THE ONLY CHANGE TO THIS LOCATION IS ON SHEET 1 AND SHEET 3A. ALL OTHER SHEETS ARE FOR REFERENCE ONLY.

| | | | | Designed: 08/21/12 TIER 3 PHASE 3 M.P.177.00 TO M.P.160.00 UPGRADE XINGS AND CP'S FOR HIGH SPEED RAIL Rec#: WO#: 22820 IS: / /MWK /NST/MJF | Designed: 6/01/12 TIER 3 PHASE 2 M.P.194.00 TO M.P.177.00 UPGRADE XINGS TO 4 QUAD WITH EGMS, VARIOUS CP'S Rec#: WO#: 14052 IS: / /NST/MJF | MODIFICATION LEVEL | | CIRCUIT MODIFICATIONS ARE NOT TO BE MADE WITHOUT AUTHORITY FROM THE OFFICE OF SIGNAL DESIGN | Date: 06/01/12 | UNION PACIFIC RAILROAD | Sh.: 1 |

ONE TRACK INTERMEDIATE
SPRINGFIELD SUBDIVISION

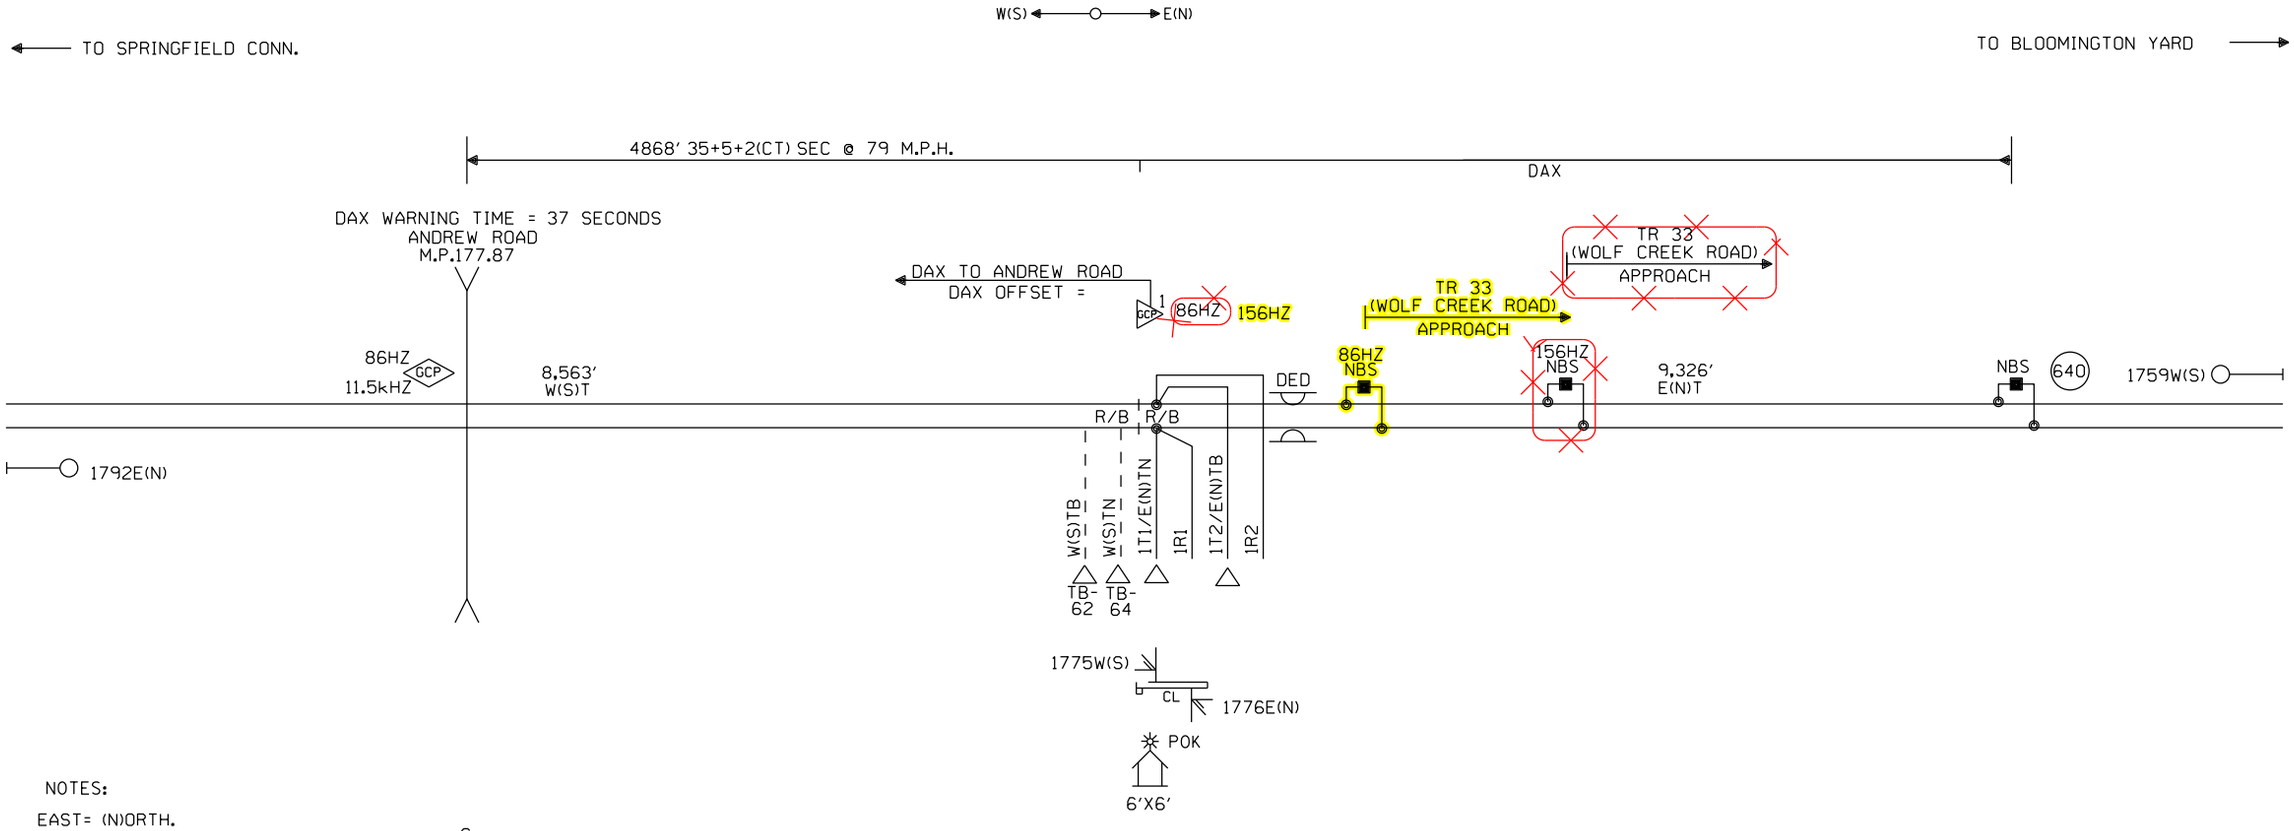
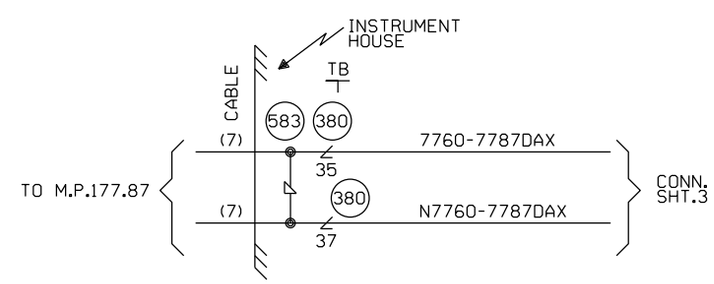
CONNECTS TO 177.87

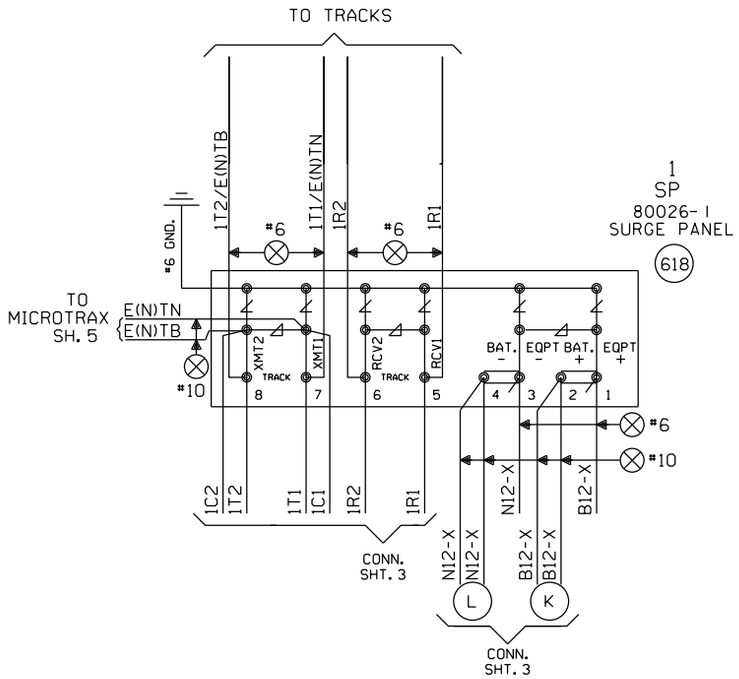
Minimum Program Steps
---
TEMPLATE: track 1-Remote Dax
Track 1: GCP Frequency = 86 Hz (Field,TCN)
Track 1: Approach Distance = 3612 ft (Set in Field,TCN)
Track 1: Dax A Warning Time = 37 sec (OCCN) *
Track 1: Dax A Offset Distance = 1256 ft (Set in Field)
Track 1: GCP Transmit Level = Medium (Set in Field,TCN)

TO BE VOIDED
08/21/12
W.O. 22820 NST/MJF

TEMPLATE: track 1-Remote Dax
Track 1 : GCP Frequency = 156 Hz (Field,TCN)
Track 1 : Approach Distance = 3612 ft (Set in Field,TCN)
Track 1 : Dax A Warning Time = 37 sec (OCCN) *
Track 1 : Dax A Offset Distance = 1256 ft (Set in Field)
Track 1 : GCP Transmit Level = Medium (Set in Field,TCN)
